Standard Drawing Report

Date: July 12, 2024

Standard Drawing Number: TM472

Drawing Title: Junction Boxes/Hand Holes

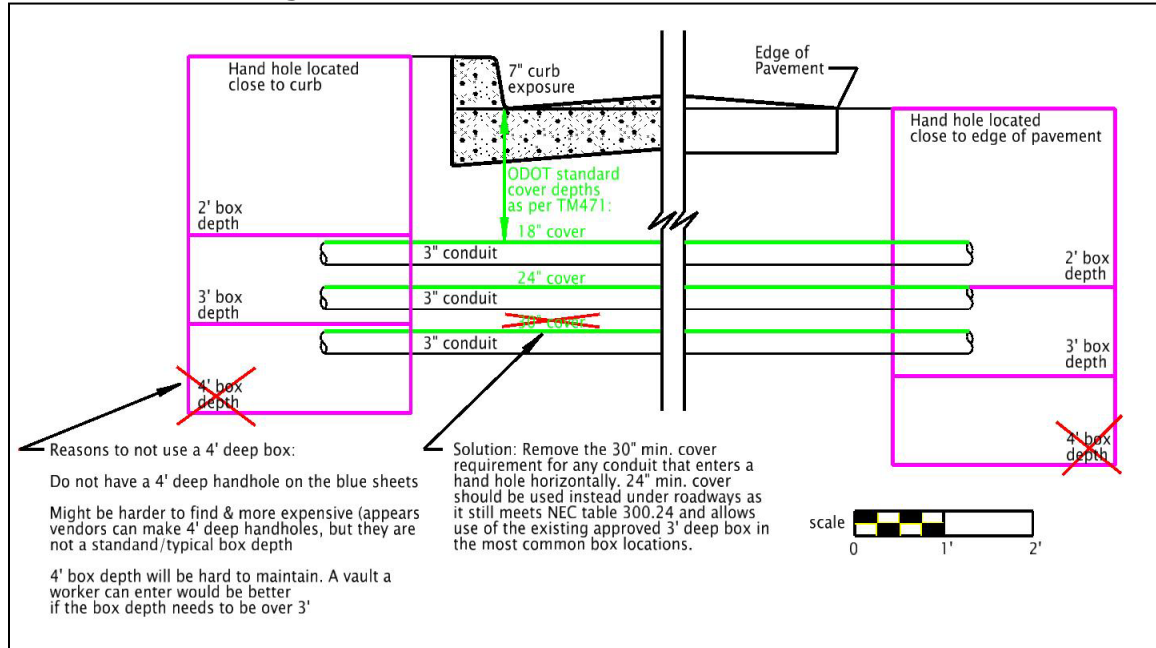
- Added "(See TM471 for cover depth exception)" to PVC conduit note in "Fiber optic cable hand hole installation" detail

This note was added due to an issue that was brought to our attention when placing a hand hole next to a curb. The elevation difference the curb creates for the horizontal conduit installation

with 30 inches of cover was a problem. See figure below. A 4 foot deep hand hole box was considered, but due to the issues shown in the figure below it was rejected. Installing the conduit under the box (using elbows) was also considered but due to high potential for damage to the fiber optic cable during installation as per the ITS standards engineer, it was rejected. Instead, reducing the cover from 30" to 24" for the horizontal conduit installation was the best solution as it still meets the minimum NEC table 300.24 requirements for cover and works with existing hand hole box sizes.
